RESOLUTION NO. 771 (14)

**A RESOLUTION OF THE PLANNING COMMISSION OF THE CITY OF
LOMPOC RECOMMENDING CITY COUNCIL APPROVAL OF A
REQUEST FOR AN ALTERNATIVE MITIGATION MEASURE,
AMENDMENT NO. 2 TO THE BURTON RANCH SPECIFIC PLAN,
AND ACCEPTANCE OF ADDENDUM TO THE
FINAL ENVIRONMENTAL IMPACT REPORT
(Planning Division File No. FEIR 02-01 /SP 04-01)**

**Environmental
Impact Report
Addendum
SCH# 2002091045**

**Subject: Burton Ranch Project - Revised Traffic Analysis for the
State Route 1 / Harris Grade Road Intersection**

Figure 2-1
City of Lompoc

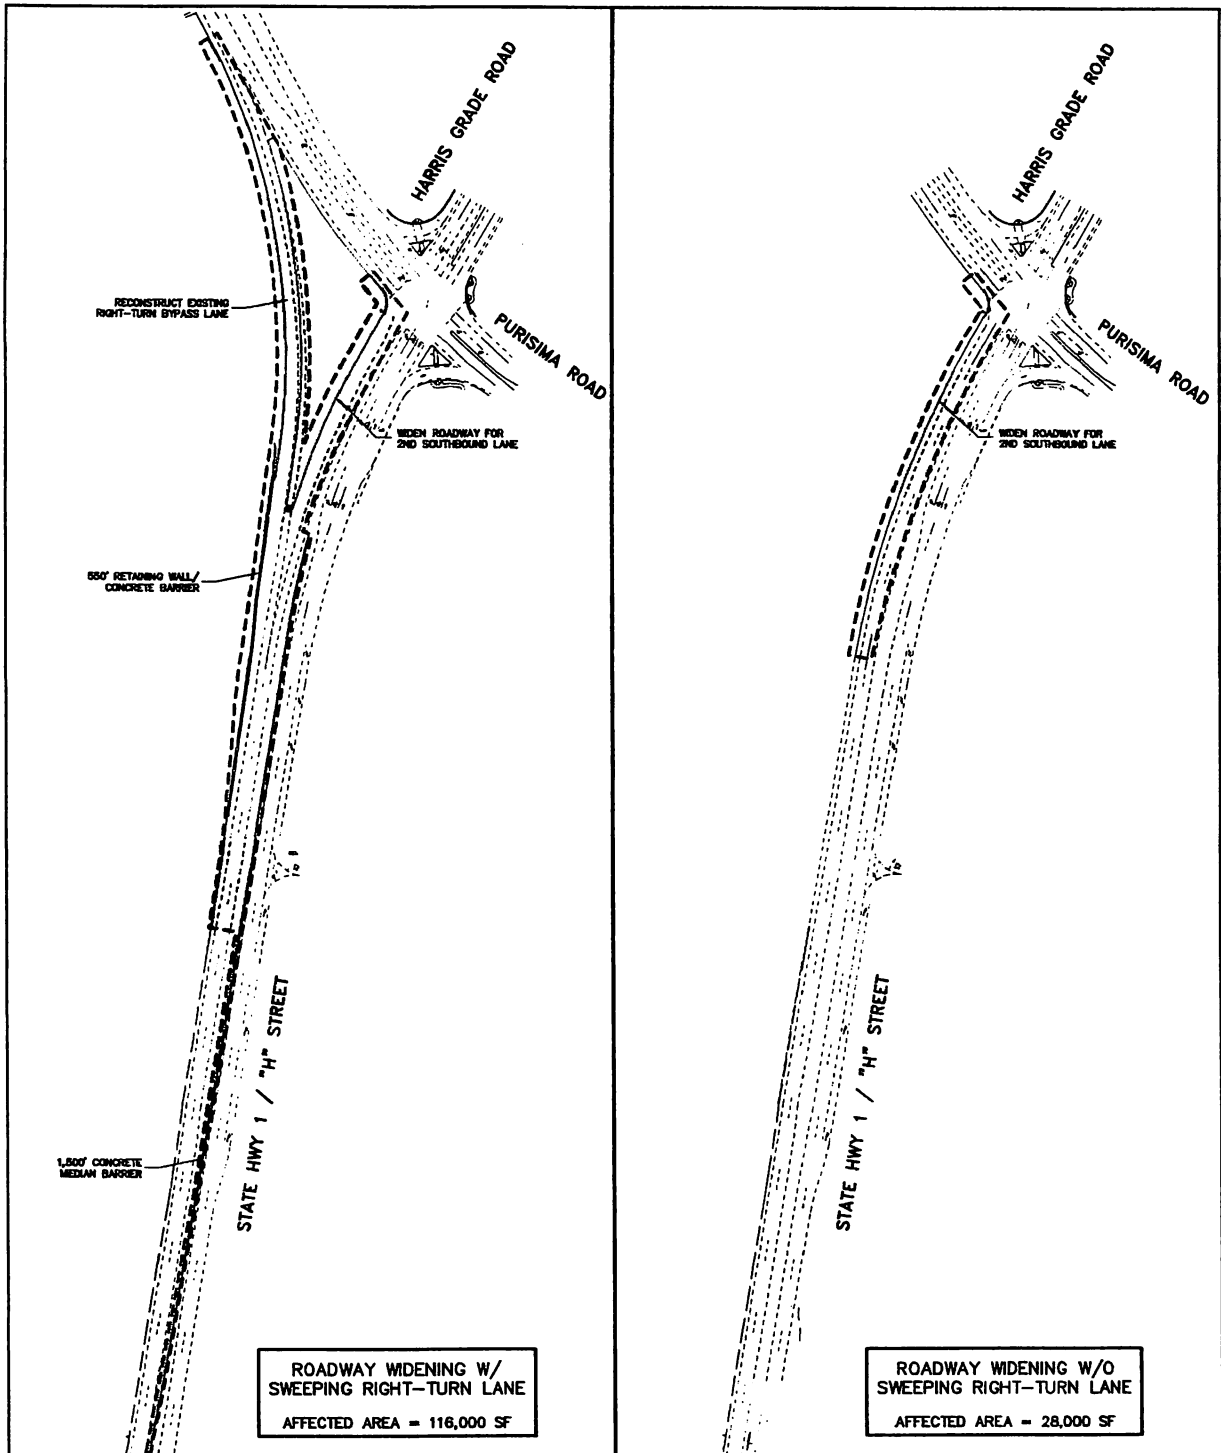
Caltrans determined that the scope and cost to complete improvements per mitigation measure TRANS-1.2c, would exceed the type of improvement typically handled under an encroachment permit and requires that the project be reviewed under a Highway Improvement Agreement (HIA), which would require additional time and cost. In summary, the combination of adding a second southbound lane on H Street and the existing merge lane creates a dual lane merging situation that requires:

- Realignment and widening of approximately 1,500 lineal feet of H Street and the right turn ramp from southbound SR 1.
- Construction of 550 feet of 9.5-foot maximum height retaining wall/concrete barrier.
- Construction of 1,500 lineal feet of concrete median barrier.

Figure 2-1 shows the difference in work area required by implementation of Mitigation Measure TRANS-1.2c with and without the presence of the eastbound to southbound sweeping right-turn lane. Following the review of the design of a second southbound lane and corresponding traffic analysis, Caltrans indicated that the substitute mitigation measure would be equally effective when compared to Mitigation Measure TRANS-1.2c.

In addition, Mitigation Measure TRANS-1.2c is proposed for replacement in the EIR and Specific Plan with the following mitigation measure:

"The applicant shall construct the following improvements at the State Route 1/Harris Grade Road intersection prior to project occupancy:

- *Restripe of the northbound approach (dual left-turn lanes, one through lane and a right-turn lane), and;*
- *Provide traffic signal improvements to change the existing split phasing to protected left-turn phasing on the northbound and southbound approaches and to protected-permissive left-turn phasing on the eastbound and westbound approaches in conformance with the future operation assumed in the 2030 General Plan Update EIR."*

EXHIBIT A
STATE ROUTE 1 / HARRIS GRADE RD
ROADWAY WIDENING COMPARISON

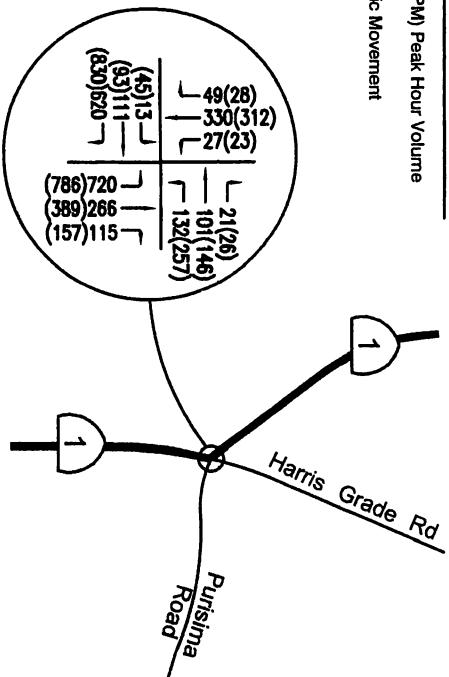
Penfield & Smith prepared a design for the second southbound lane mitigation TRANS 1.2c, as contained in the 2005 project FEIR. Under typical conditions, this improvement would involve roadway widening for several hundred feet north and south of the intersection, tapering back into the existing roadway. However, at this intersection, a sweeping right turn from southbound State Route (SR) 1 merges onto H Street south of the intersection. The combination of adding a second southbound lane on H Street and the existing merge lane creates a dual lane merging situation that requires:

- Realignment and widening of approximately 1,500 lineal feet of H Street and the right turn ramp from southbound SR 1.
- Construction of 550 lineal feet of 9.5-foot maximum height retaining wall/concrete barrier.
- Construction of 1,500 lineal feet of concrete median barrier.

Exhibit A provides a visual representation of the difference in work area required by implementation of TRANS 1.2c with and without the presence of the eastbound to southbound sweeping right-turn lane. The additional cost associated with this expanded work area and scope is estimated at \$1.3 million. Caltrans has indicated that the scope and cost to add this second southbound lane exceeds the type of improvement typically handled under an encroachment permit and requires that the project be reviewed under a Highway Improvement Agreement (HIA), which could require additional time and cost. A revised traffic analysis with an alternate mitigation was therefore completed at the suggestion of Caltrans, following their review of the design of a second southbound lane.
